Application for Resource Consent - 110 Jervois Quay - SR 5101418 – Section 92 Further Information Request

16.10 110 Jervois Quay
Resource Consent
Sunlight Analysis
19th May 2022

16.10 110 Jervois Quay
Resource Consent
Outlook Assessment Views
16th May 2022

APPENDIX 7 – REVISED PLANTING PLAN

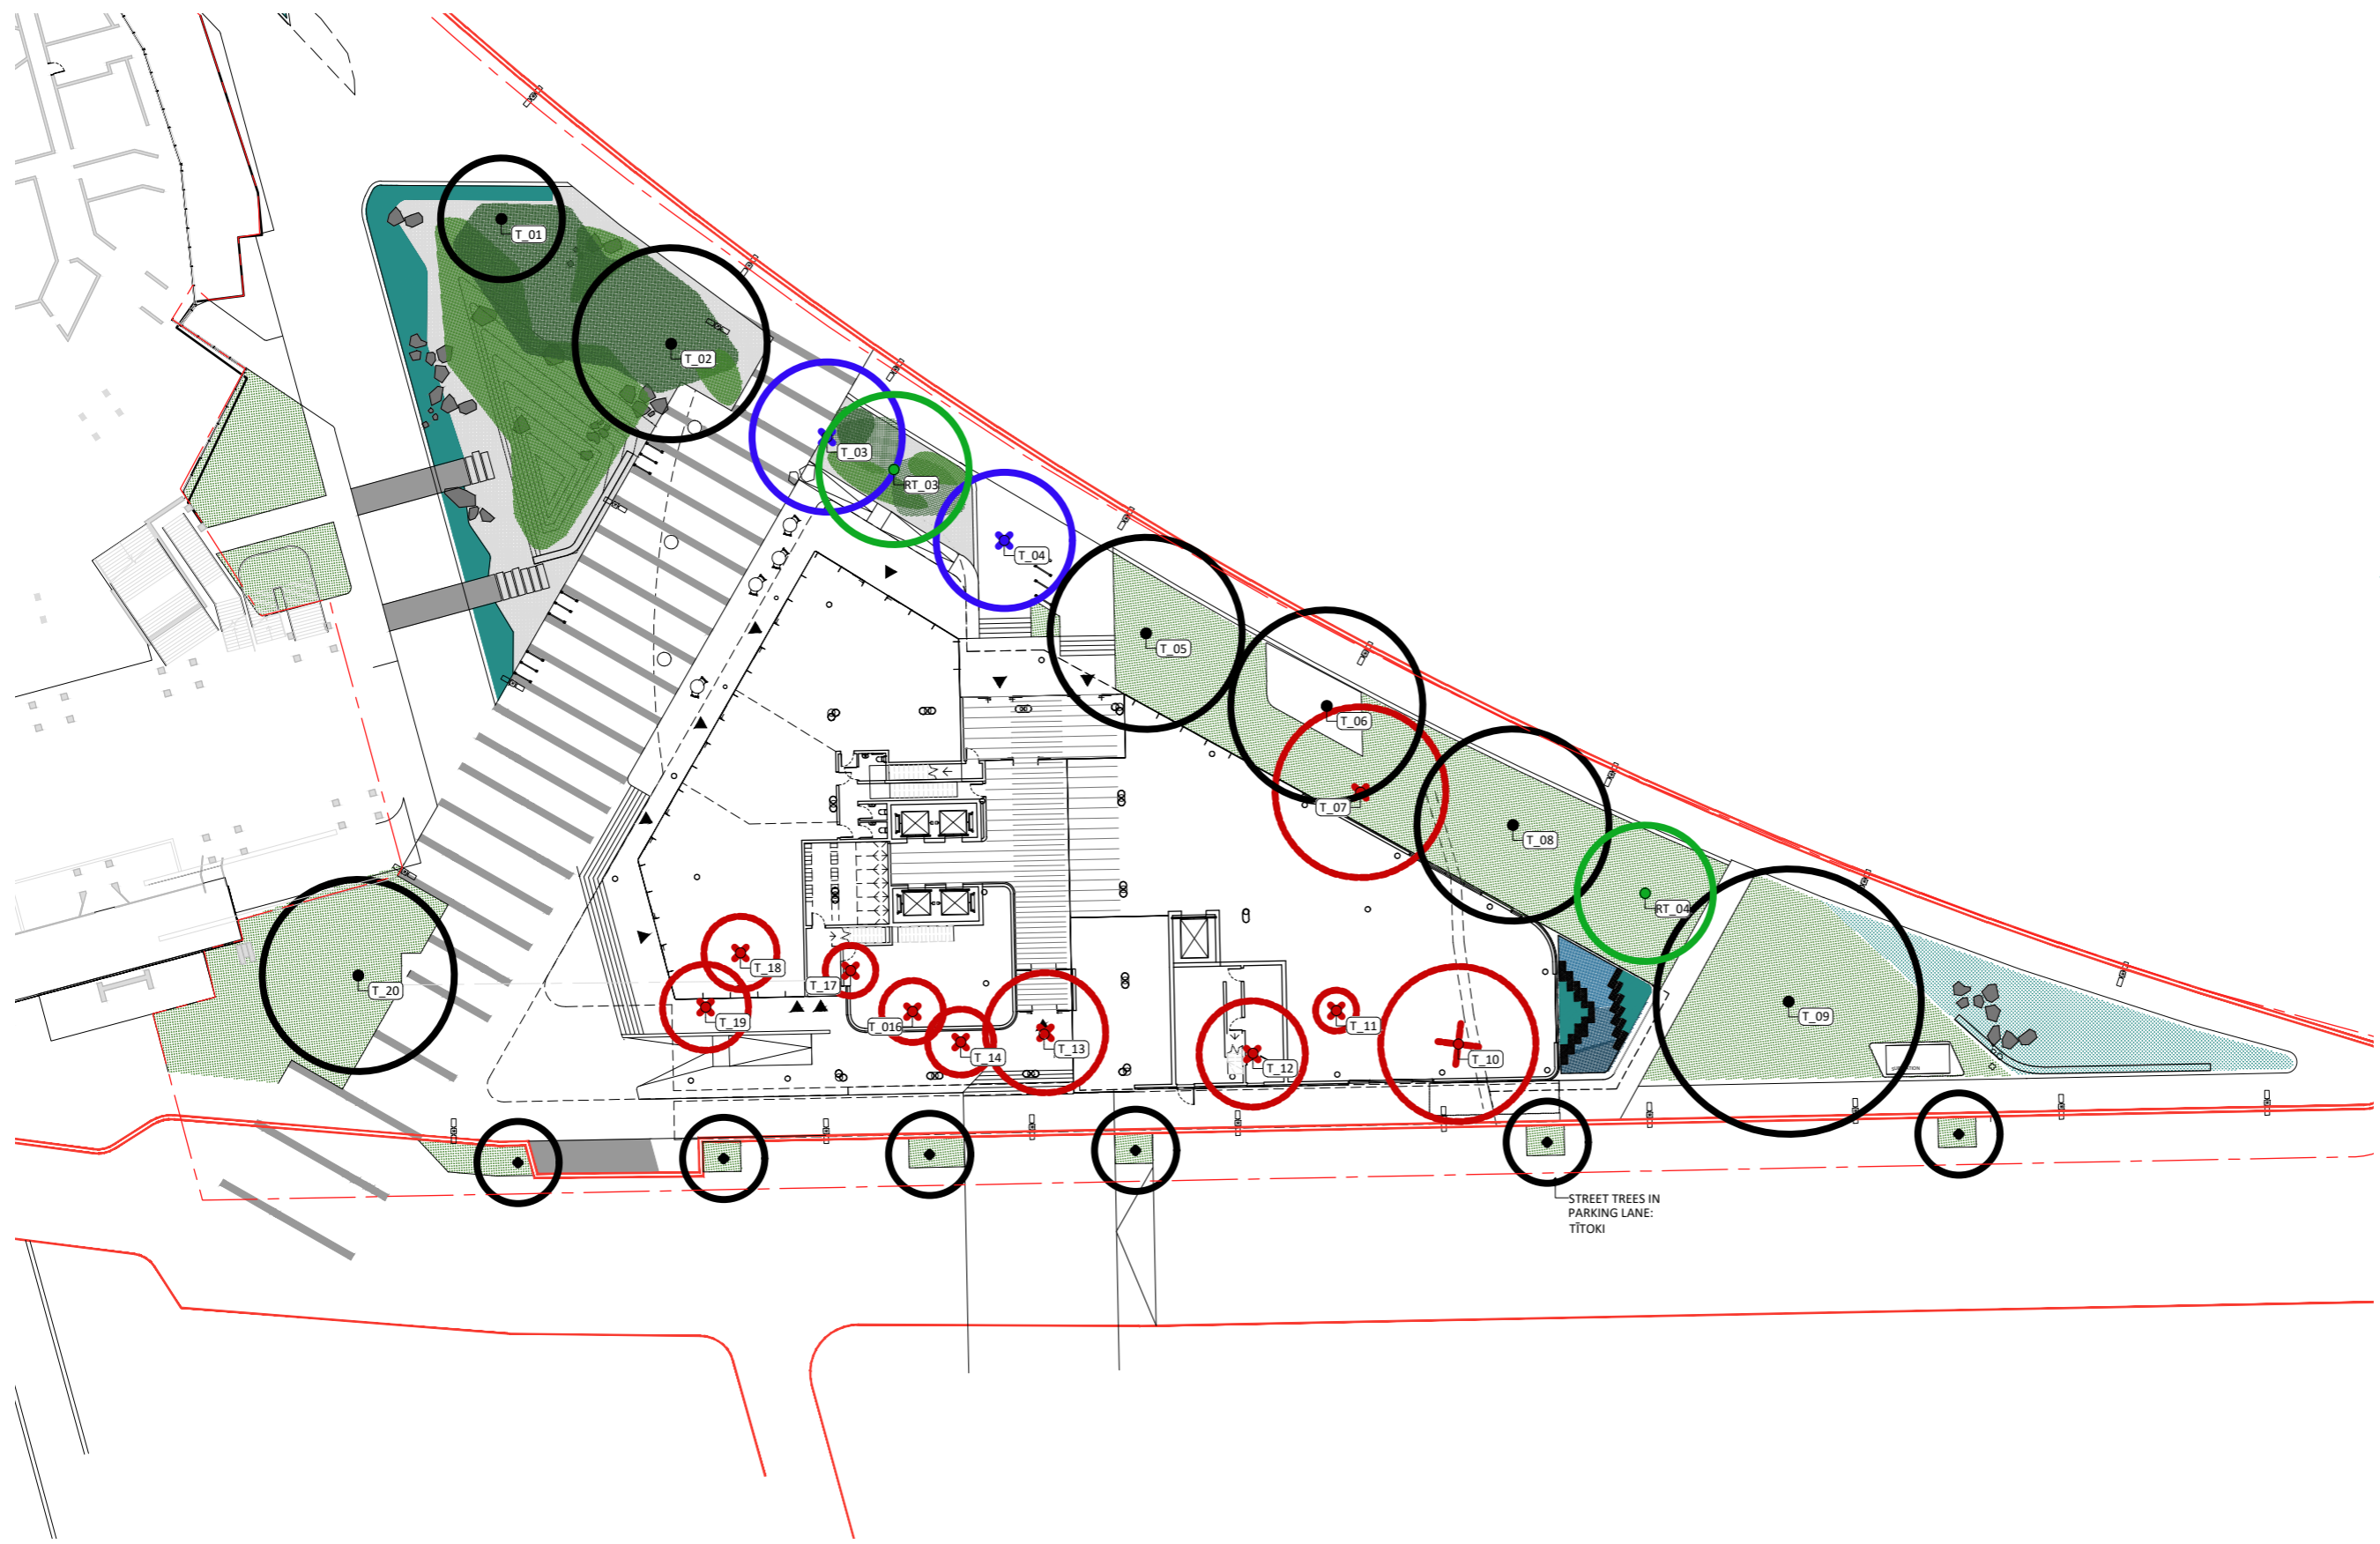
- 7. No new tree planting will be accepted over the public stormwater culvert and where possible tree's which may impact on the culvert performance should be removed and / or root barriers installed. It is unclear from the landscape plan if the tree's in this area are new or existing – Can the applicant please advise.*

As regards tree planting, please see attached as Appendix 7 revised planting plan prepared by Wraights & Associates Ltd (this plan replaces L1.04 provided with the original application). The proposed new locations for two relocated trees have been adjusted to ensure neither tree (nor their roots) will impact on the stormwater culvert.
